**Alex Avenue Public School – State Significant Development – Application Number SSD\_9368 (“SSD\_9368”)**

We refer to the modification application (being modification no. 3) pursuant section 4.55(1A) of the *Environmental Planning and Assessment Act 1979* (NSW) (“**EP&A Act**”) to modify SSD\_9368 in relation to the Alex Avenue / Galungara Public School (“**MOD 3**”).

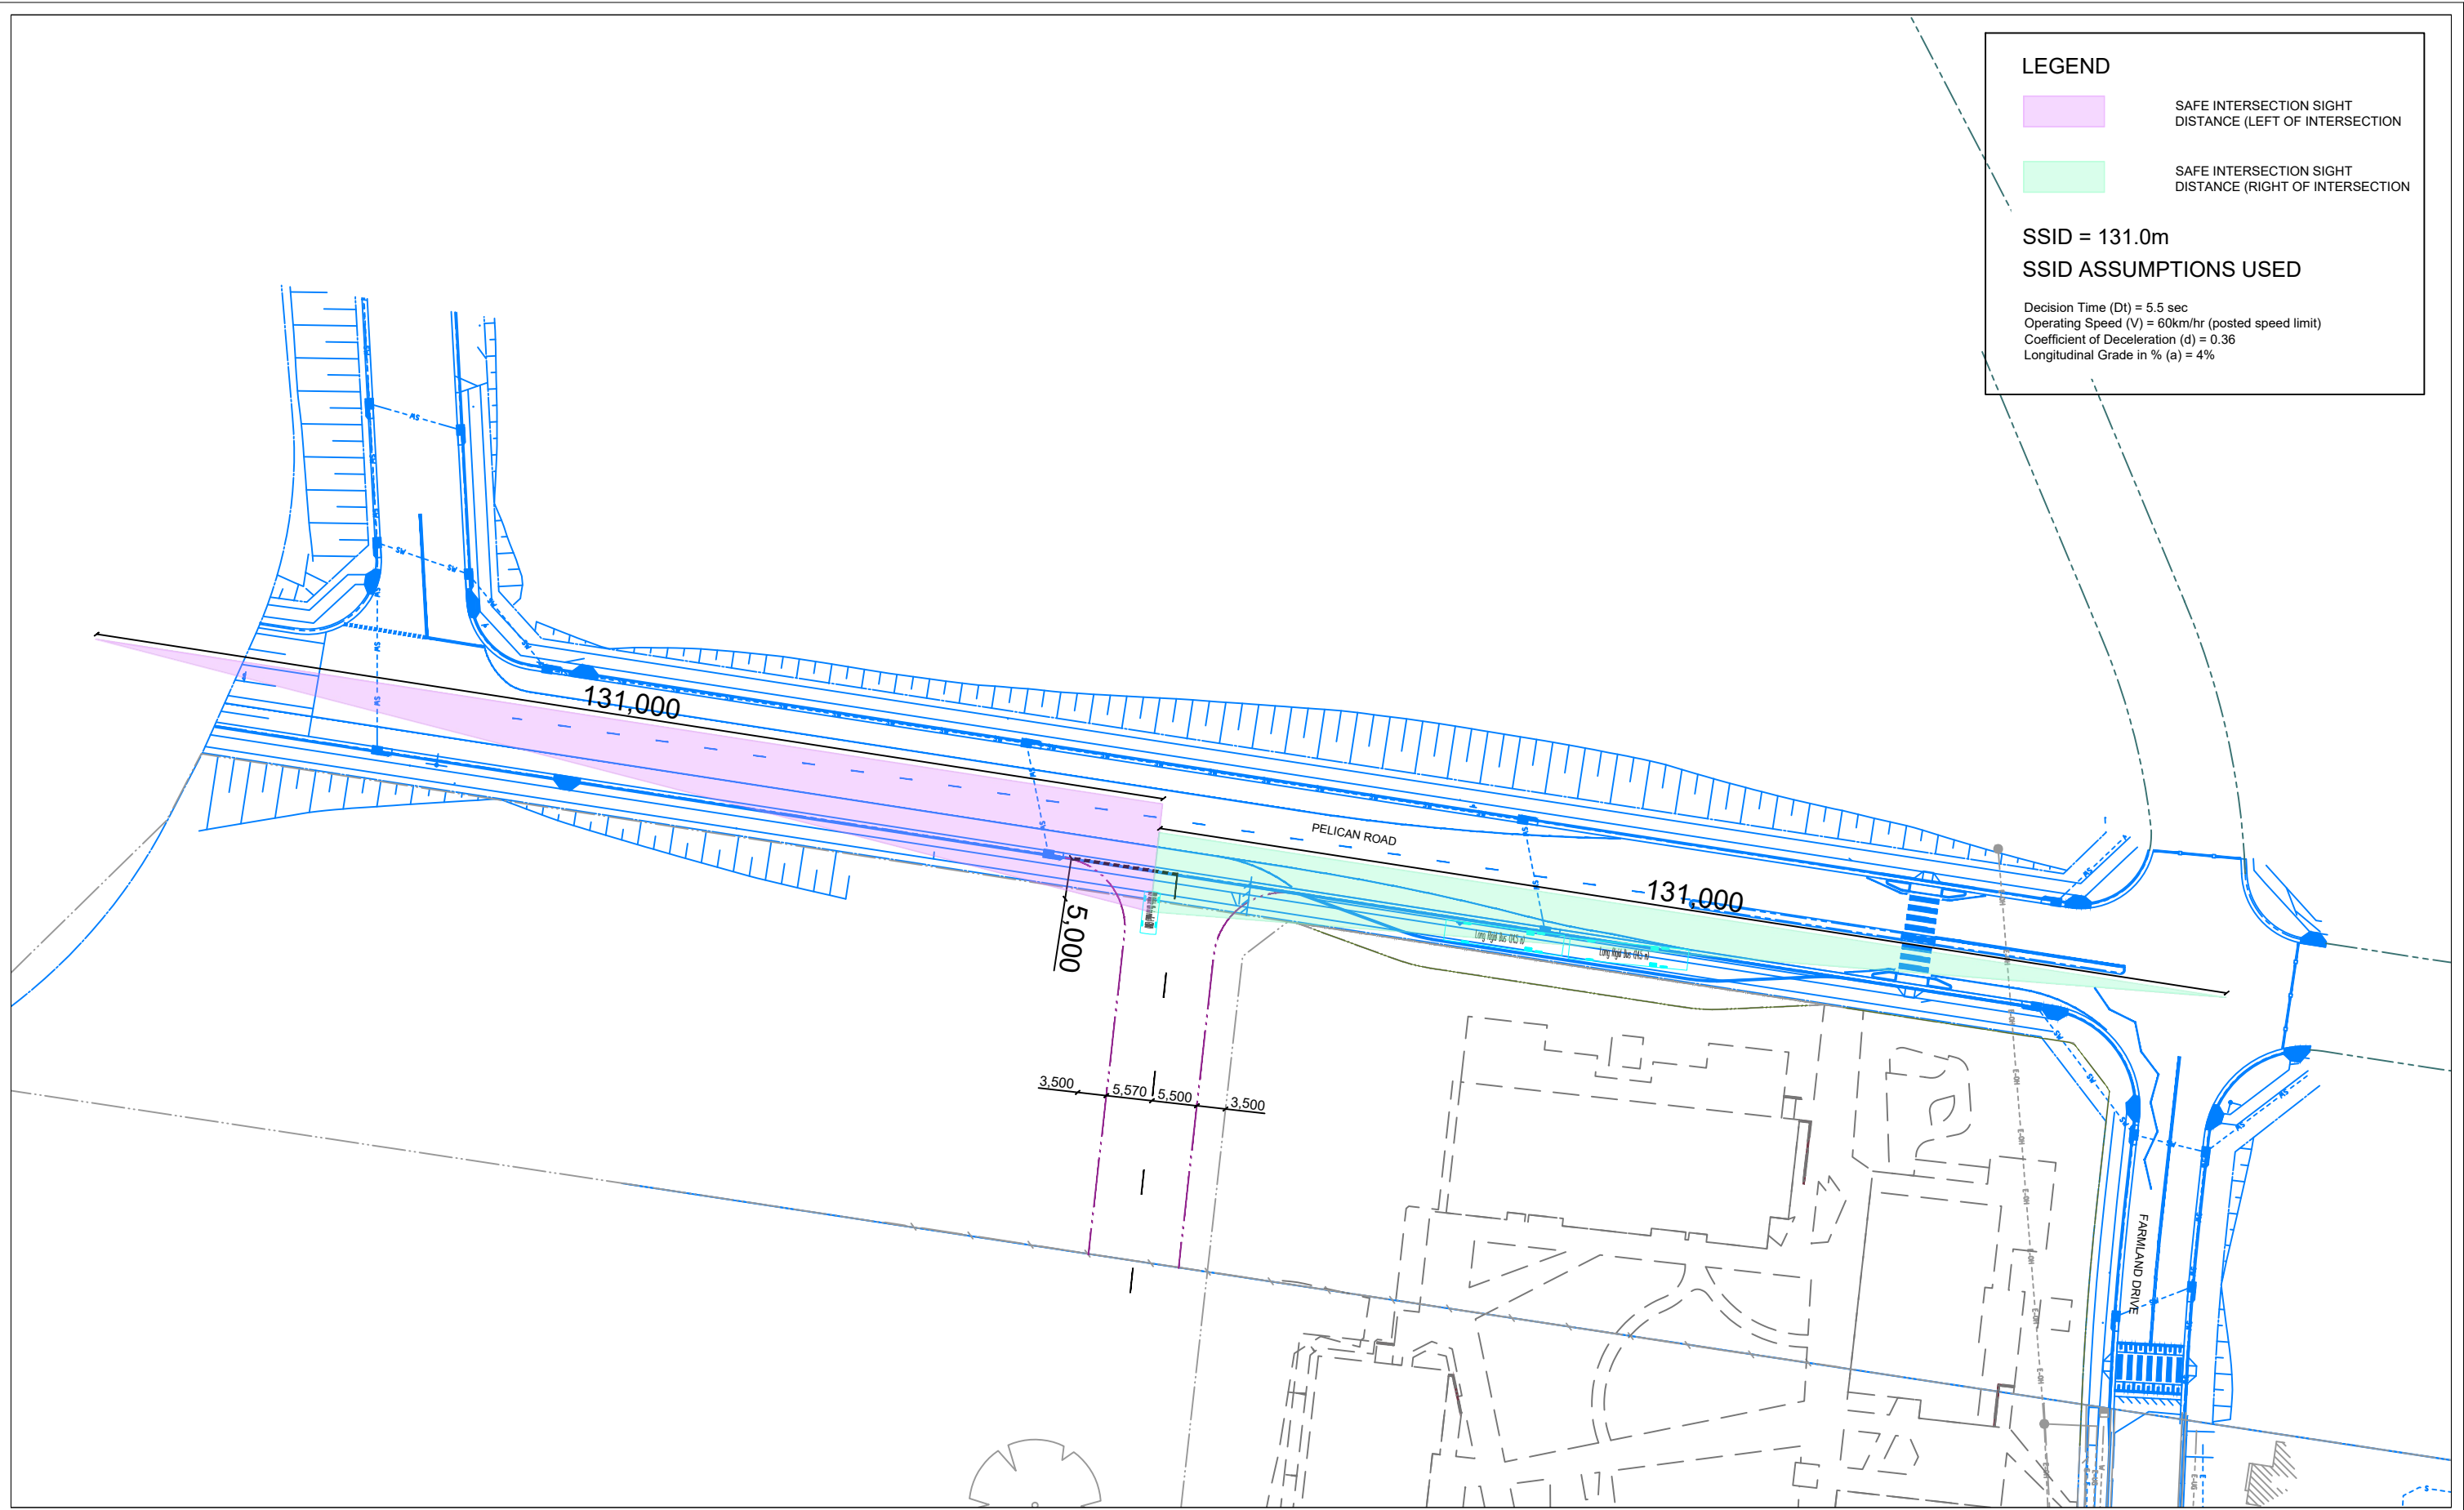
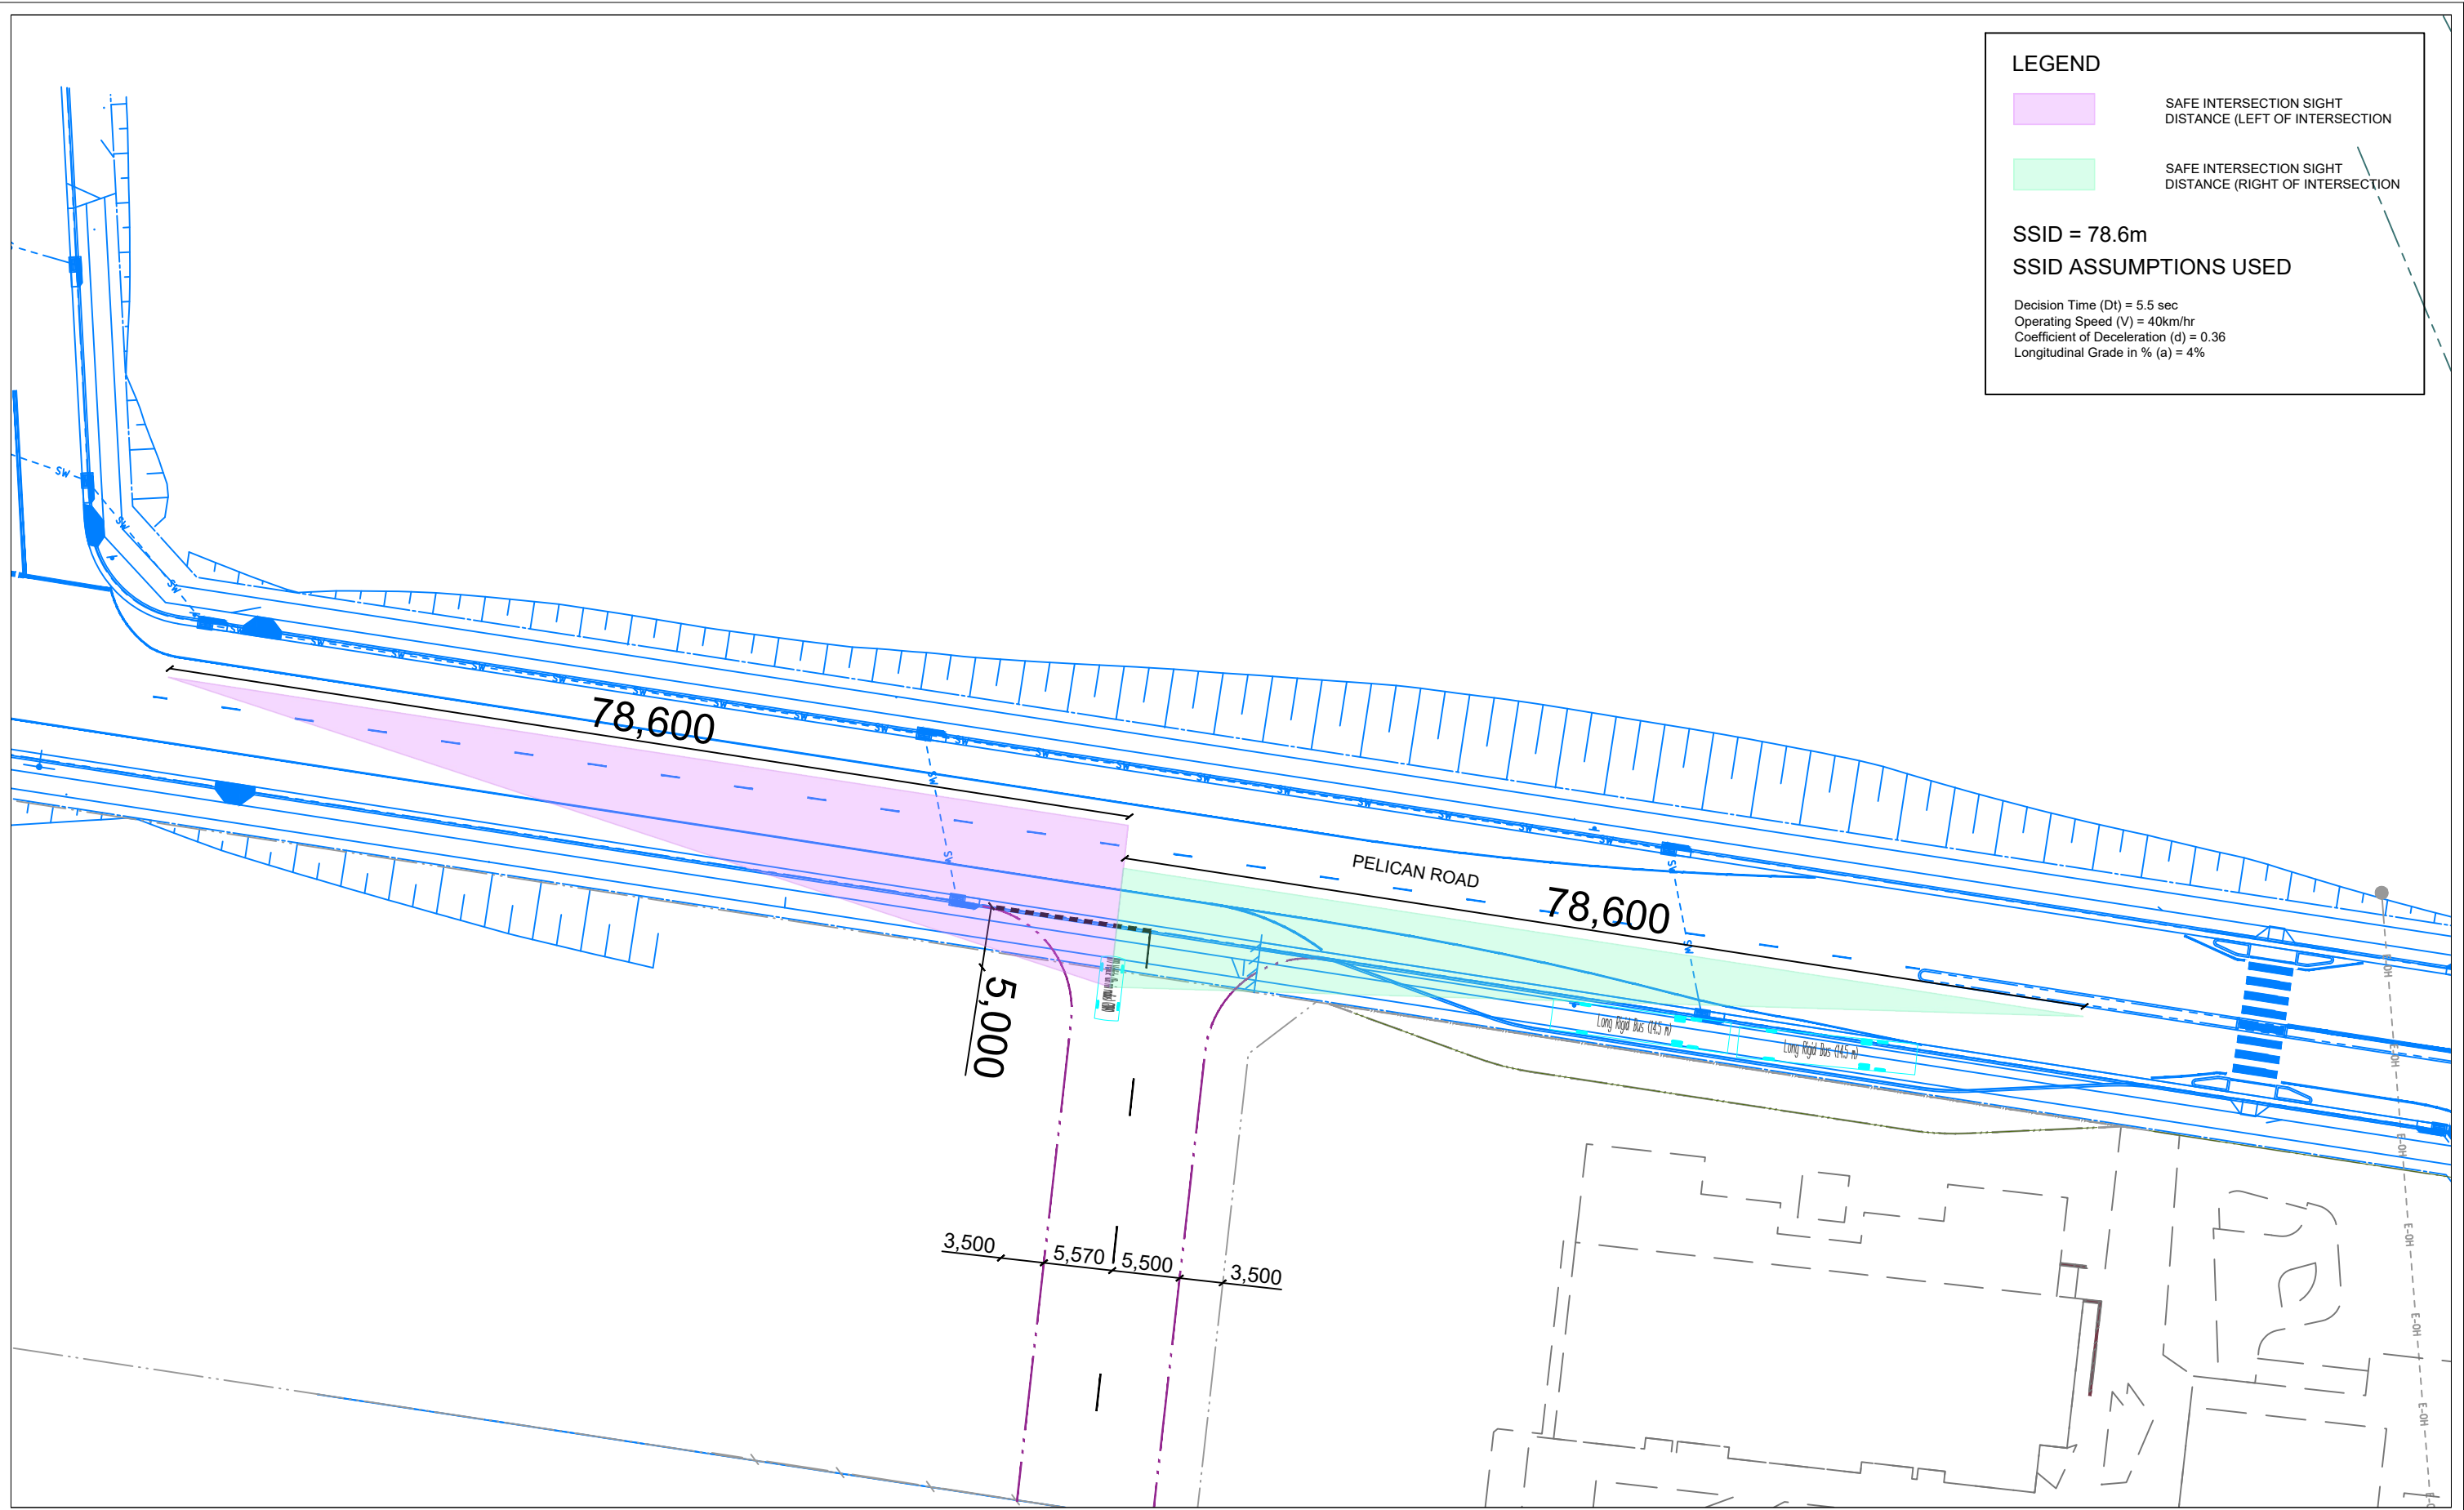
*"The outcome of that sightline assessment was provided on Sheet 02 of 10 attached to the GTA letter and is reproduced in the following pages, revealing that the sightlines required to achieve safe intersection sight distance in accordance with Austroads was 160.5m. Significantly however, **the GTA sightline assessment did not take into account the proposed bus bay which is illustrated on Sheet 03 of 10 in the GTA letter (also reproduced in the following pages) which has now been approved under SSD 9368.**"*

*If analysis exists which shows a sightline assessment that does take into account the proposed bus bay, please provide us with a copy of that analysis. If such analysis does not exist, please confirm this is the case.*

We offer the following response to Varga Traffic's peer review comments.

A revised SISD assessment has been completed based on approved Northrop Civil Design Drawings (which incorporates the approved Toplace road construction drawings) based on three scenarios:

As identified previously in GTA's assessment, the indented bus bay are for school bus use only. Further consultation undertaken with the local bus operator and TfNSW further confirmed that if a school bus is to be introduced, the school bus will only access the bus bay during the AM drop off and PM pick up period as part of a modified, linked public transport route. Buses are typically not expected to dwell within the indented bus bays for extended periods of time.
